MINUTES
Recreation Advisory Commission
Wednesday, February 6, 2013 – 5:30 p.m.
City Hall – Council Chambers

Presentation – Band Shell

ARMADILLO BANDSHELL

MUSCATINE MILLENNIUM PLAZA &
RECREATION PARK
RIVER FRONT
MUSCATINE, IOWA

SITE GRADING PLAN

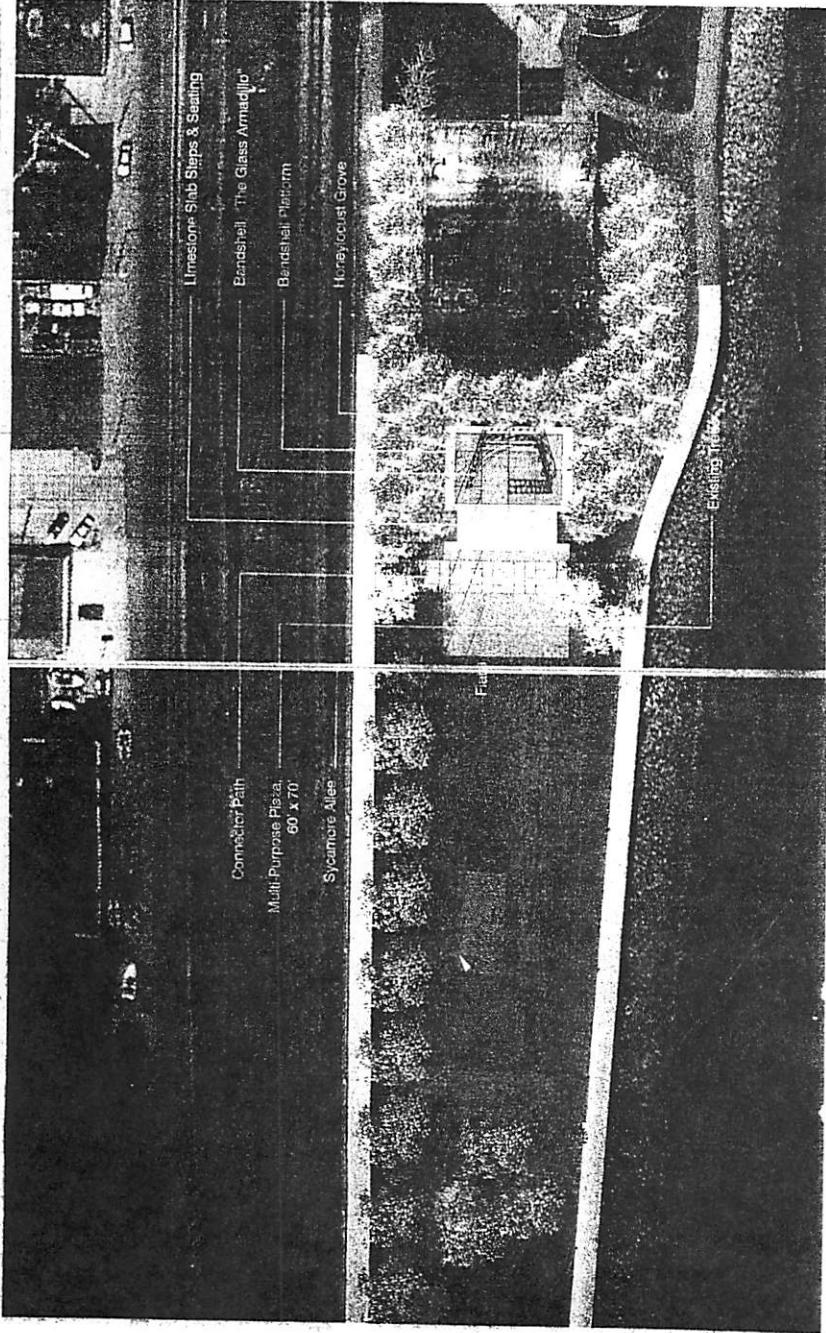
Mayor Hopkins distributed handouts to the Commission and discussed the Glass Armadillo Band Shell concept plan. The band shell would be located on the riverfront in the grassy area next to the basketball courts. This area is six feet higher in elevation than the surrounding terrain; therefore, putting the structure further out of reach to possible flooding.

Klimes asked Even to discuss the trees in the concept plan. Even stated the concept plan is calling for Sycamore trees to be placed along the trail. These trees can reach a height of 75 feet and are not a good idea for this area. They are very messy, have loose twigs, susceptible to disease which would cause the loss of leaves, and the seed pods will stain the concrete. There is an irritant in the pods as well. The concept plan also calls for Locust trees to be placed behind the Band Shell. These trees can reach a height of 75 feet as well and will block the view from the city side. Klimes asked the Commission if they were okay with the loss of visibility to the river. The Commission stated they were not in favor of that idea. Kraft stated she believes there needs to be trees due to people needing shade on hot summer days, but maybe not as many as the plan calls for. Kassel stated there needs to be different tree choices.

Klimes asked the Commission if they liked the location for the Band Shell. Harper stated it would be better up river due to there already being an access road. All other Commission members thought the location was okay.

Commission Member Kraft moved to approve the concept plan for the Glass Armadillo Band Shell as presented by Mayor Hopkins subject to: the project include an adequate access and egress to the site that will not damage the trail, the design address positive drainage needs at the site, limit the amount of trees with a tree species review provided by the Tree Committee, the project site should not have a raised berm in the center grass area, no loose rock material in the landscaping plan, review of glass construction material for a more maintenance friendly material, and an identified funding source for future maintenance. Seconded by Commission Members Kassel, Warren, Bark, Riley, Kraft, and Wagner. One nay: Commission Member Harper. Motion carried.
